From: "DAVANT, GUY H" <GDAVANT@entergy.com>
To: "twa@nrc.gov" <twa@nrc.gov>
Date: 4/27/04 12:06PM
Subject: FW: Slides for NRC Conference Call on April 27, 2004

Response to NRC Questions

Figure 6– Results of EPFM Stability Analysis for ANO-1 Top Head Remnant Cracking Concern

Figure 2: Correlation of Coefficient C of Power Law J R-curve Representation with Charpy V-notch Upper Shelf Energy [5]

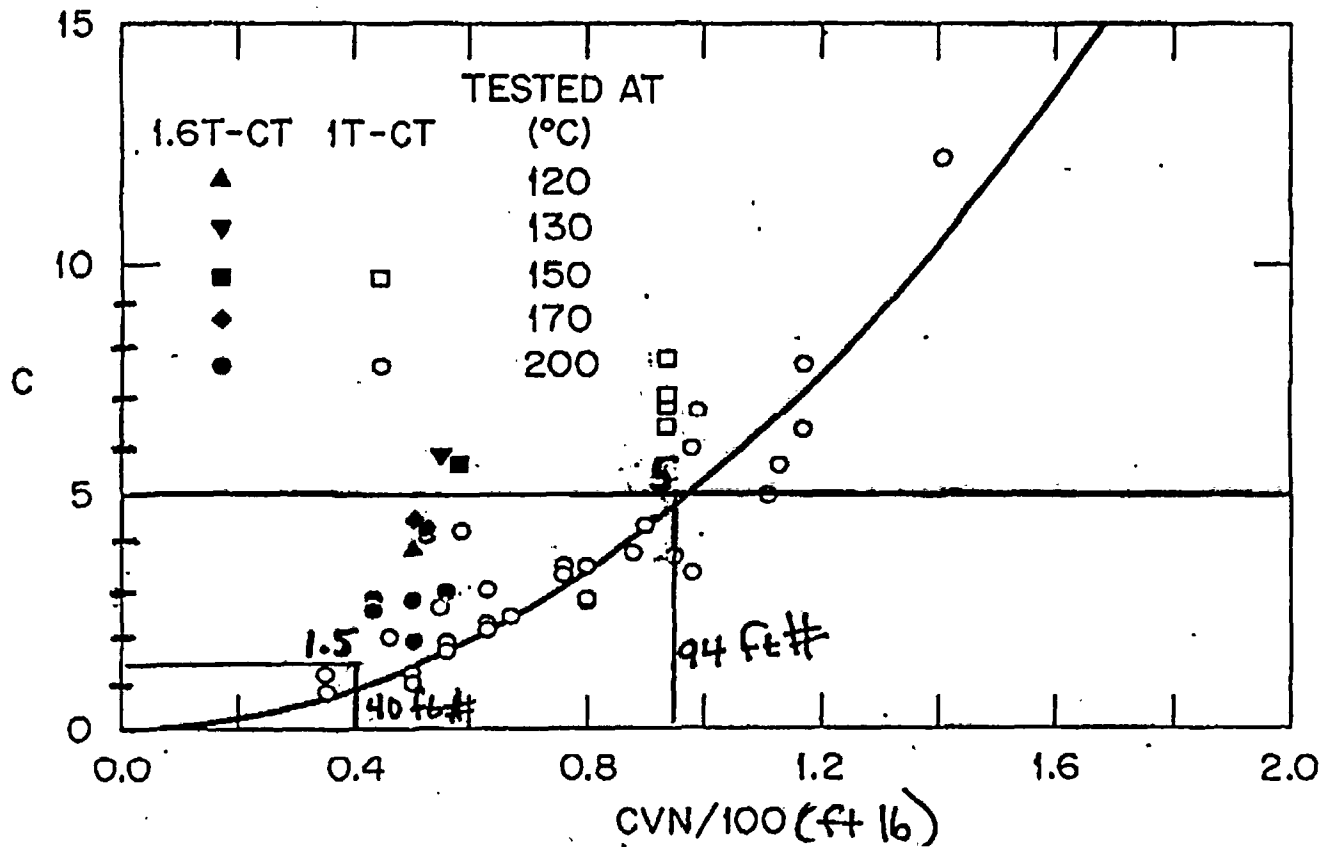
1. Upper shelf Charpy V-notch energy (USE) estimates for the ANO-1 head material were developed as shown in Figure 4. This Figure indicates three Charpy energy data points derived from measurements on the ANO-1 head material at +10° F. The actual measurements were higher, but they were measured in the Longitudinal direction, so they were reduced for the Transverse direction in accordance with USNRC SRP/NUREG-75/087 MTEB 5-2 Position 1.1 B-3a. These are obviously not on the upper shelf, so they have been plotted on a complete Charpy Energy plot for a comparable material (GGNS beltline plate, comparable thickness, Transverse direction). The three ANO points fall well within the range of the GGNS data at +10°F, and therefore, the GGNS data, which exhibit USEs ranging from 94 to 120 ft-lbs, are considered representative of the ANO-1 head material USE. The lower bound value of 94 ft-lbs was used, in conjunction with J-T versus Charpy USE correlations in NUREG-0744 (Figures 2 and 3), to estimate a conservative J-T curve for the analysis.

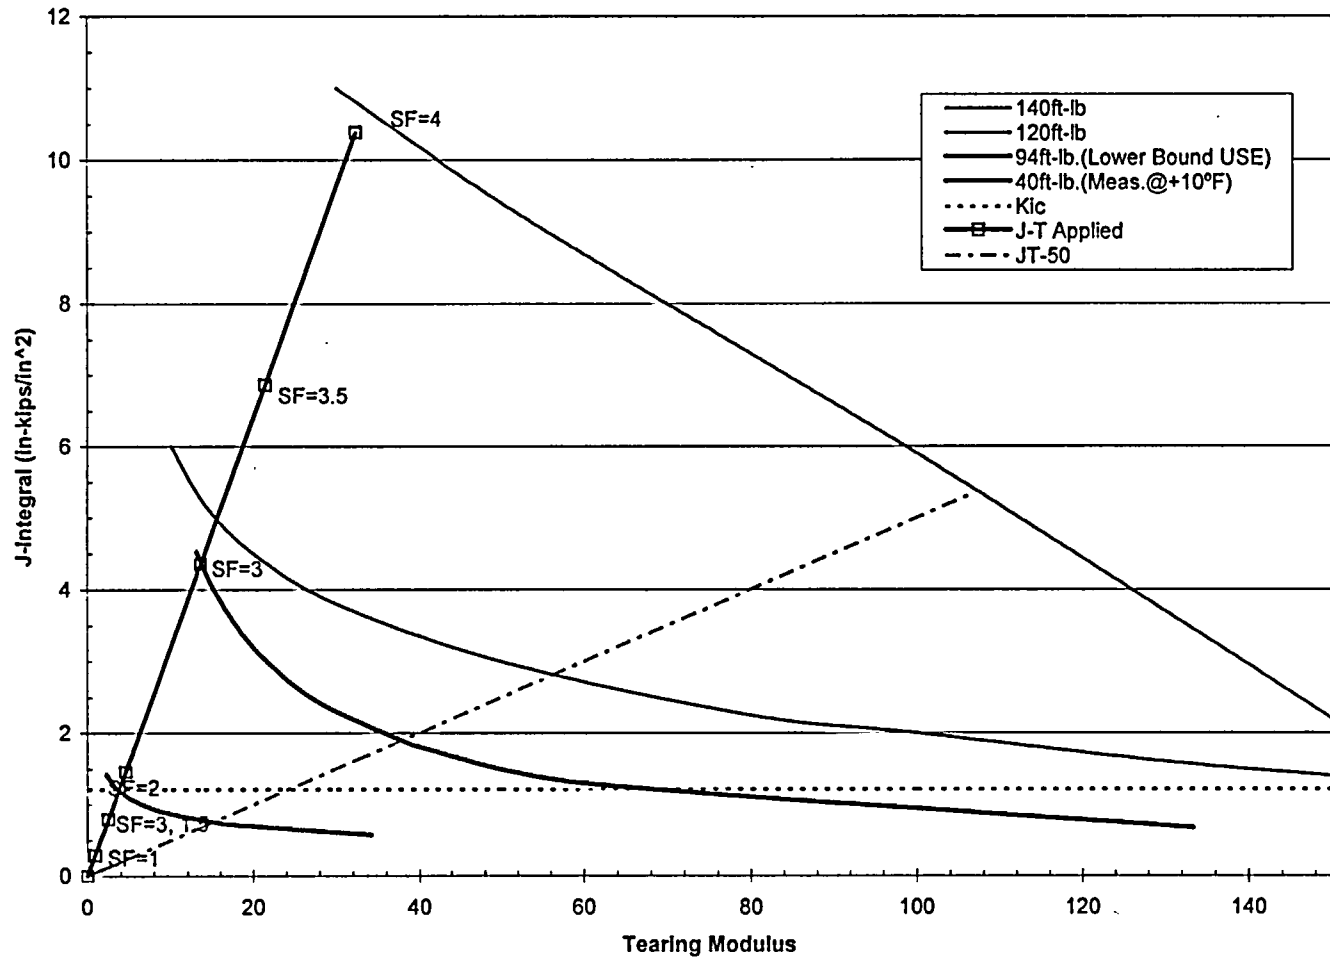
4. The analysis demonstrates large margins between applied J-integral and the crack instability point (i.e. the point where the applied J-T line intersects the appropriate J-T material curve) in all cases. In Figure 6, it is seen that the applied J-T point for the recommended safety factors of 3 on primary loads and 1.5 on secondary (residual) loads is below even the 40 ft-lb J-T material curve, which was measured at +10 for the ANO-1 head material, and is an extreme lower bound of USE for this material. Considering a more reasonable estimate of J-T material for the ANO-head material on the upper shelf (the 94 ft-lb curve – still a lower bound) shows ample margin to instability, and even supports application of the full safety factor of 3 on both primary and secondary (residual) loads.
